Architectural Supplemental Instruction No. 001

Project: Audie Murphy Hospital - Ward Upgrades/Expansion 4A

Issuance Date: March 5, 2015

Subject: Supply Ductwork

Item No. 1 — Sheet MH2.2 – Partial Fourth Floor Interstitial Space - New Construction - HVAC

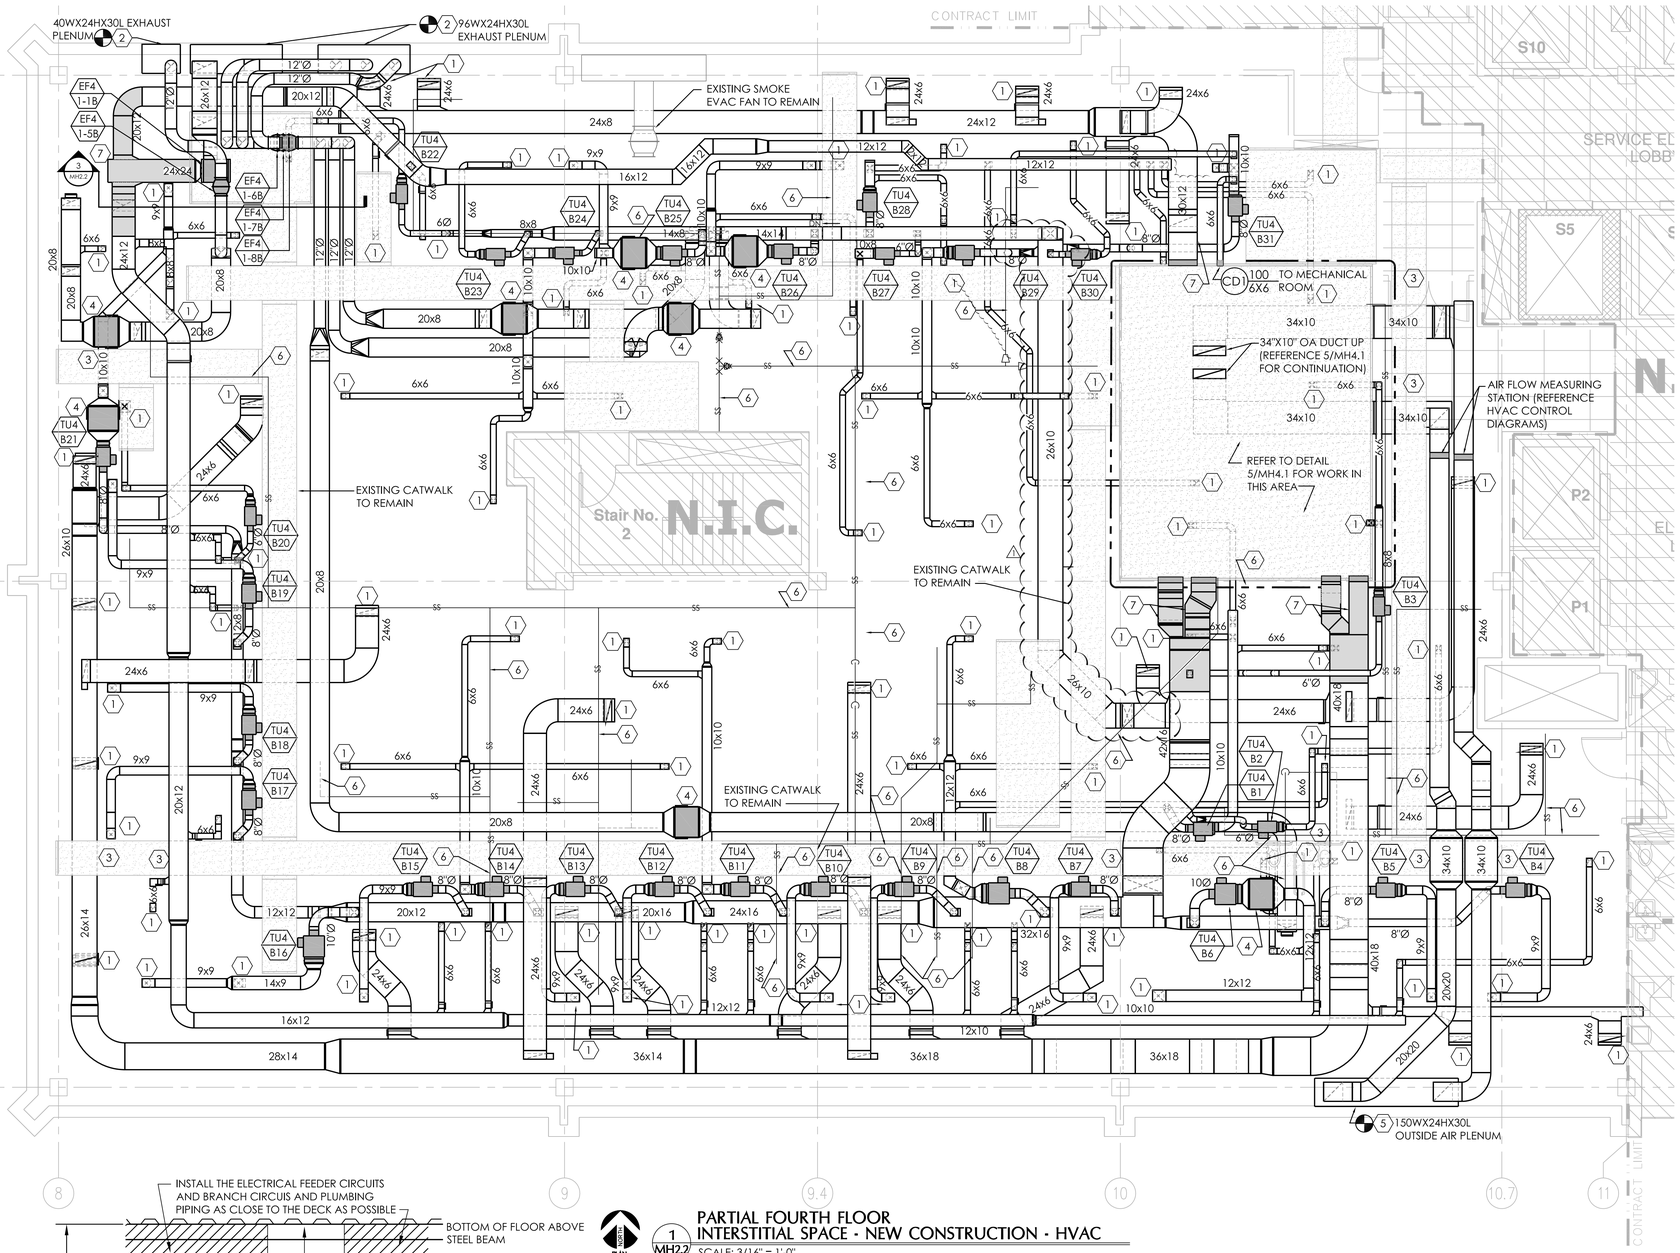
1. Furnish and install 26x10 supply duct as shown on the attached drawing.
2. Offset the exhaust air ductwork and position VAV boxes as required to accommodate the existing structure as required by General Note 3 on sheet MH2.2 and as shown on the attached drawing.

Item No. 2 — Sheet MH2.3 – Partial Fourth Floor Interstitial Space - New Construction – Hydronic Piping

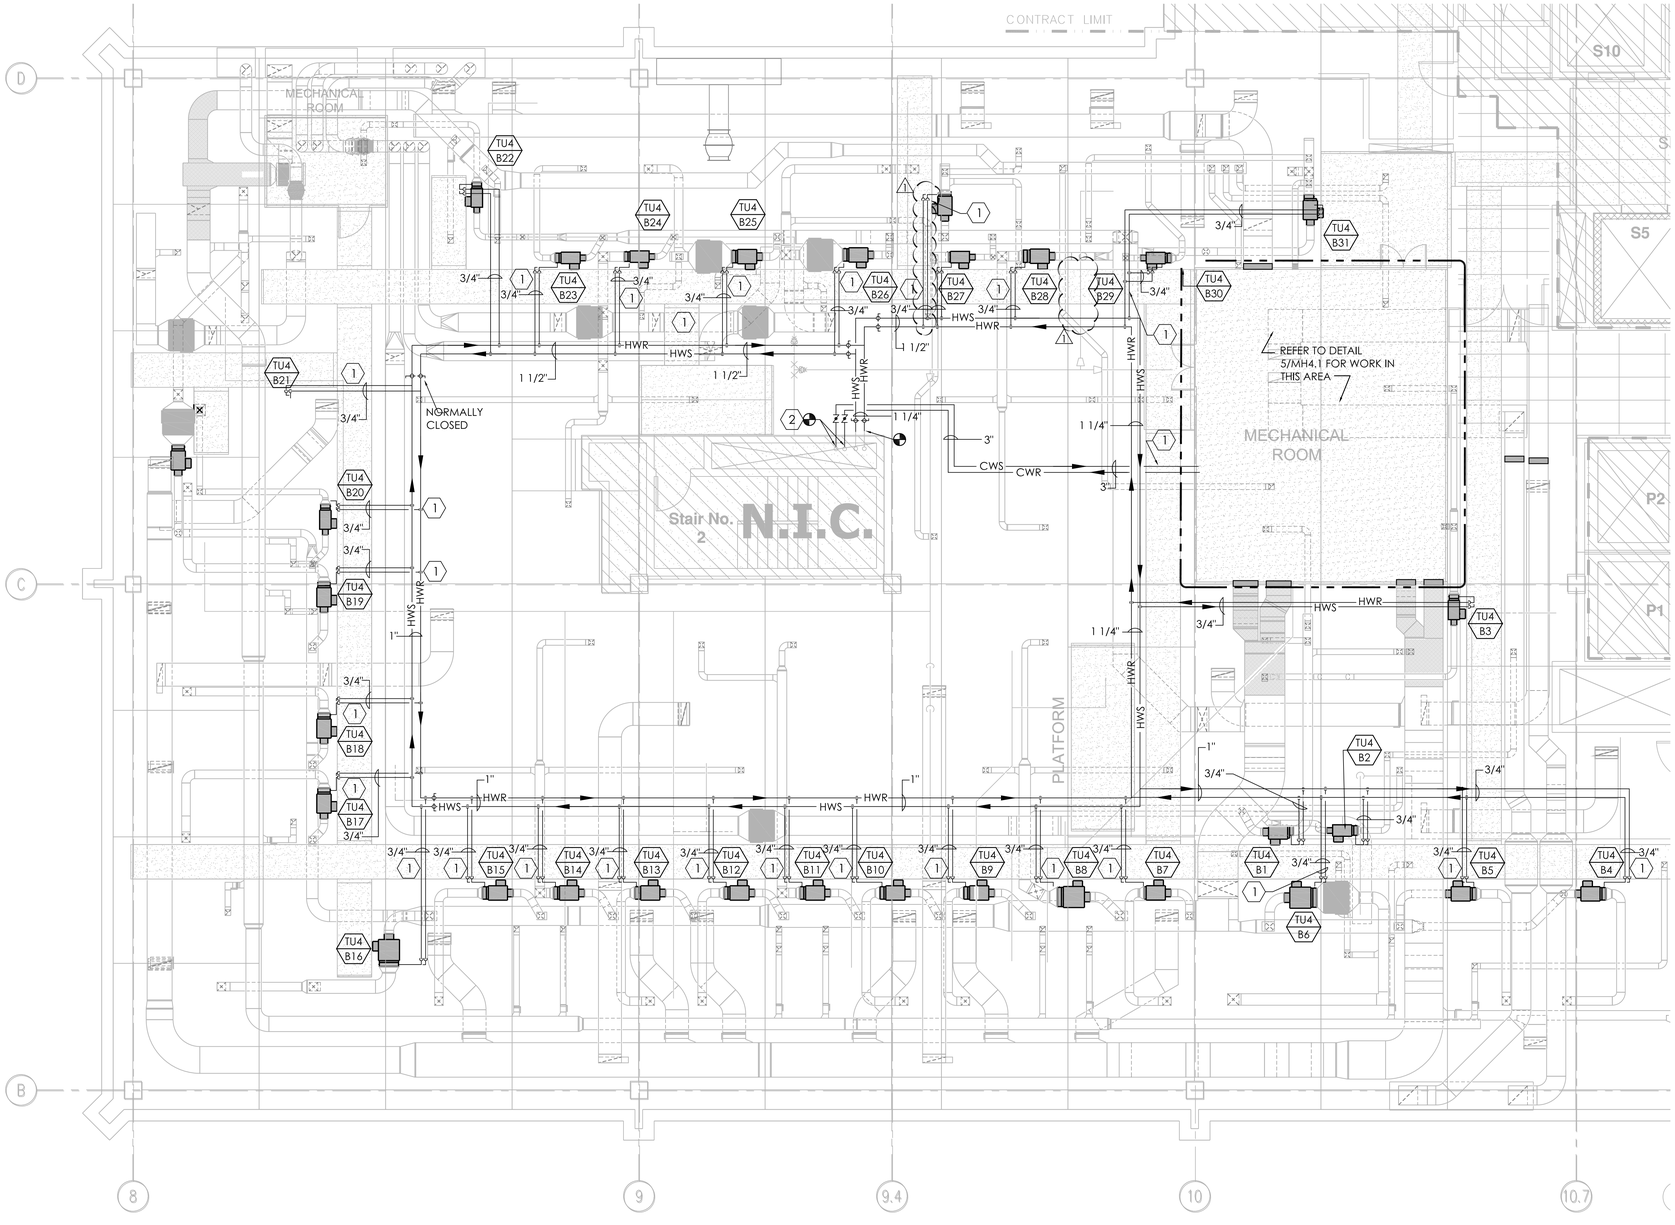
1. Route the Hydronic piping to VAV Boxes positioned as required to accommodate the existing structure as shown on the attached drawing.
